GROUP	MODEL
BOD	2021-2024MY Seltos (SP2)
NUMBER	DATE
326	July 2024

TECHNICAL SERVICE BULLETIN

HORN ASSEMBLY INSPECTION/REPLACEMENT

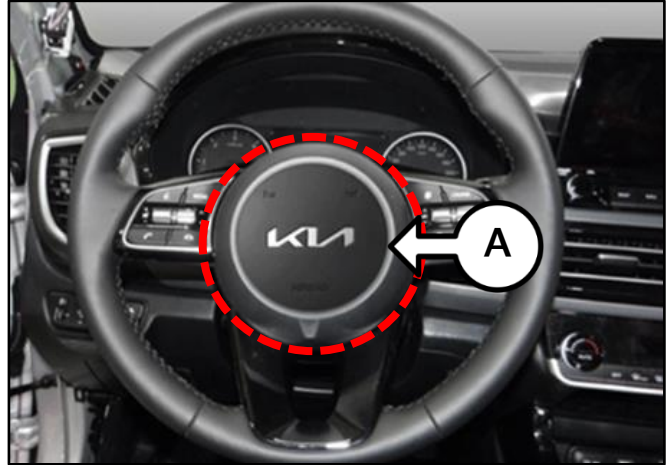
1. Replace the Horn (B) by referring to "Body Electrical System → Horn → Repair procedures" in the applicable Shop Manual on KGIS.

Tightening torque for bolt:
8.7 - 10.1 lb.ft (11.8 - 13.7 N.m)

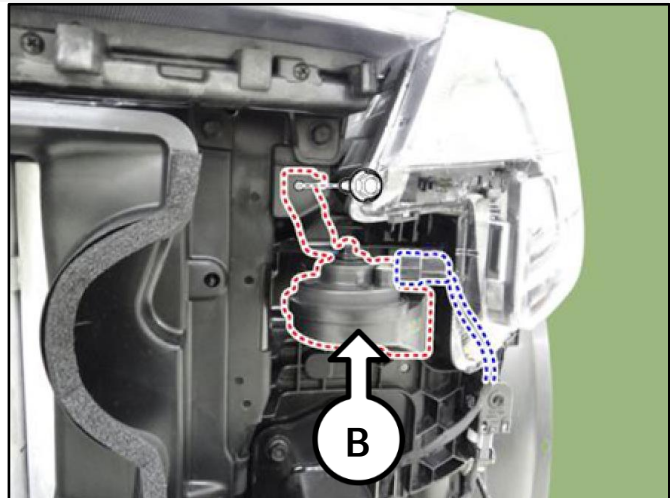
1. Press the Horn Pad (A) to confirm normal operation.
 - If the horn operates **normally**, this TSB does not apply. **Claim Inspection Only labor op 242044R1.**
 - If the horn is **inoperative** or the **tone is distorted**, proceed to the 'Replacement Procedure' below.
